HYUNDAI
Technical Service Bulletin

GROUP	NUMBER
RECALL	24-01-027H-8
DATE	MODEL(S)
JULY 2024	SEE APPLICABLE MODEL LIST

SUBJECT: ANTI-LOCK BRAKING SYSTEM (ABS) FUSE REPLACEMENT (RECALL 251)

This TSB supersedes TSB#24-01-027H-7 to add alternate part numbers for Santa Fe Sport (AN) and Santa Fe (NC) models. Both the original and alternate part numbers are acceptable for use for Santa Fe Sport (AN) and Santa Fe (NC) models on this recall. The multi-fuse design shape differs slightly between the part numbers. Use the appropriate Op Code when using the alternate part number.

Multi-Fuse Table:

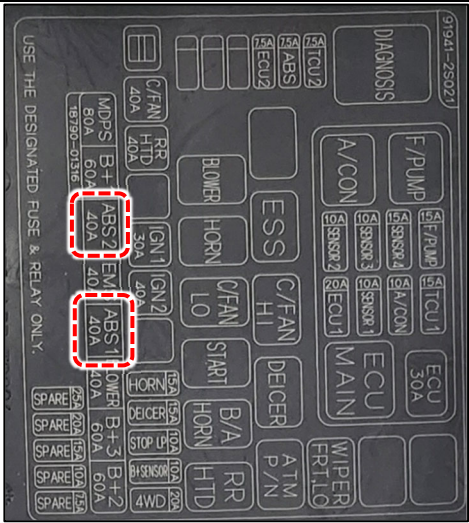
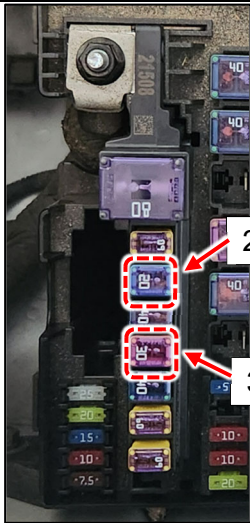
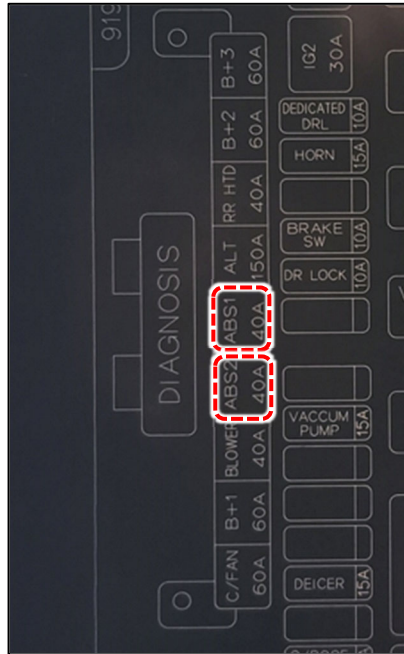
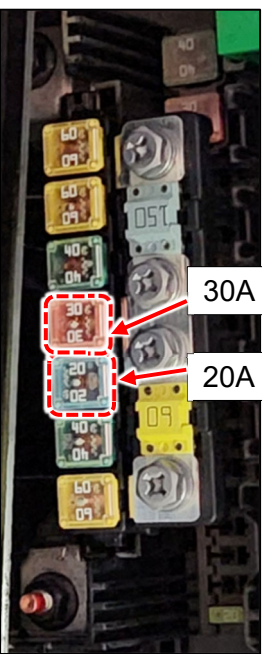
Model	Fuse Changes	Images
<p>Santa Fe Sport (AN)</p>	<p>ABS1: 40A → 30A ABS2: 40A → 30A</p>	
<p>Santa Fe (NC)</p>	<p>ABS1: 40A → 30A ABS2: 40A → 30A</p>	
<p>Accent (RB)</p>	<p>ABS1: 40A → 30A ABS2: 40A → 20A</p>

Single Fuse Table:

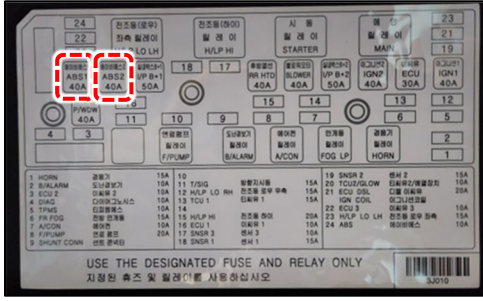
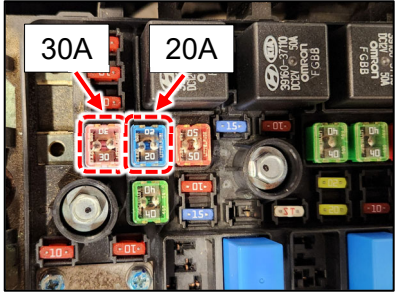
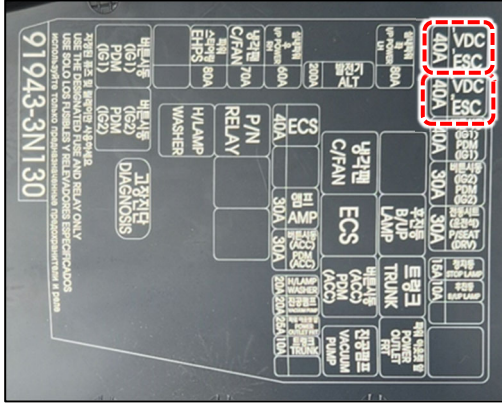
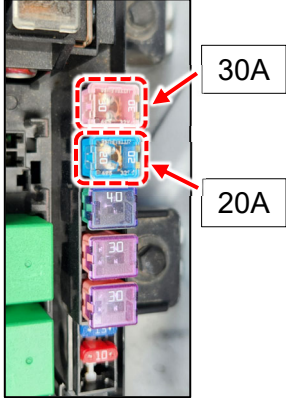
Model	Fuse Changes	Images
Sonata Hybrid (YF HEV)	ESC1: 40A → 30A ESC2: 30A → 20A

<p>Veracruz (EN)</p>	<p>ABS1: 40A → 30A ABS2: 40A → 20A</p>		
<p>Equus (VI)</p>	<p>ESC1: 40A → 30A ESC2: 40A → 20A</p>

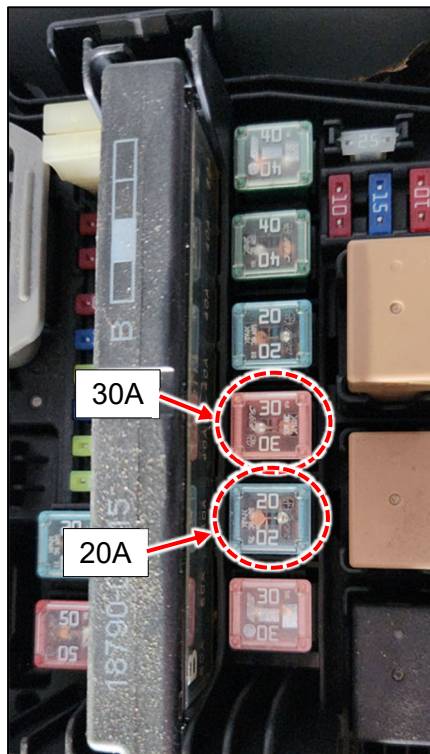
- Install the two new single fuses as shown.

ESC1 position (40A fuse originally)
Install new 30A fuse (pink).

ESC2 position (30A fuse originally):
Install 20A fuse (blue).

Single & Multi-Fuse Table:

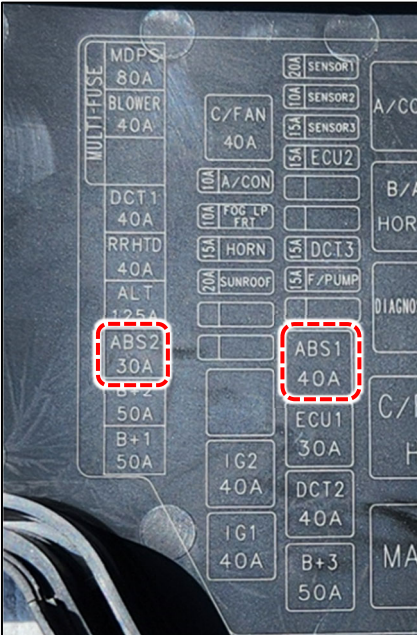
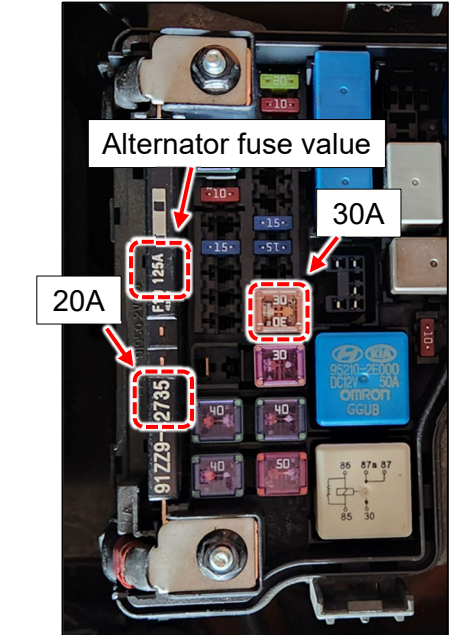
Model	Fuse Changes	Images
Azera (HG)	ESC1: 40A → 30A ESC2: 40A → 20A	
Elantra (MD/UD) & Elantra Coupe (JK)	ABS1: 40A → 30A ABS2: 30A → 20A

<p>Veloster (FS)</p>	<p>ABS1: 40A → 30A ABS2: 30A → 20A</p> <p>Veloster Turbo uses a 150A alternator fuse</p> <p>Veloster Non-turbo uses a 125A alternator fuse</p> <p>The multi-fuse is labeled with the alternator fuse value</p>		
----------------------	---	--	---

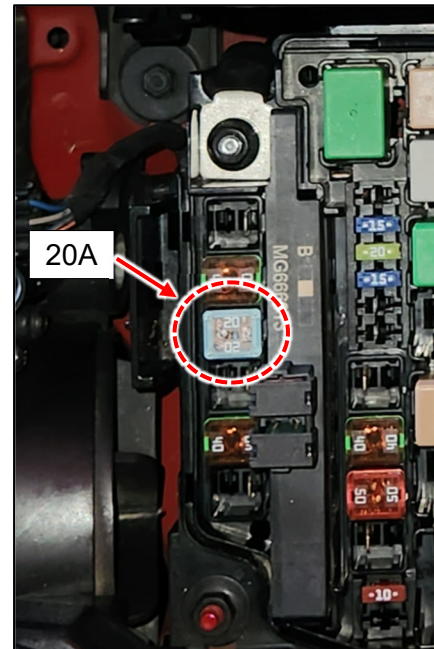
5. Install the new single fuse as shown.

For Elantra (MD/UD), Elantra Coupe (JK), and Azera (HG) vehicles:
 ABS2/ESC2 position (30A fuse originally):
 Install 20A fuse (blue).

For Veloster (FS) vehicles:
 ABS1 position (40A fuse originally):
 Install 30A fuse (pink).
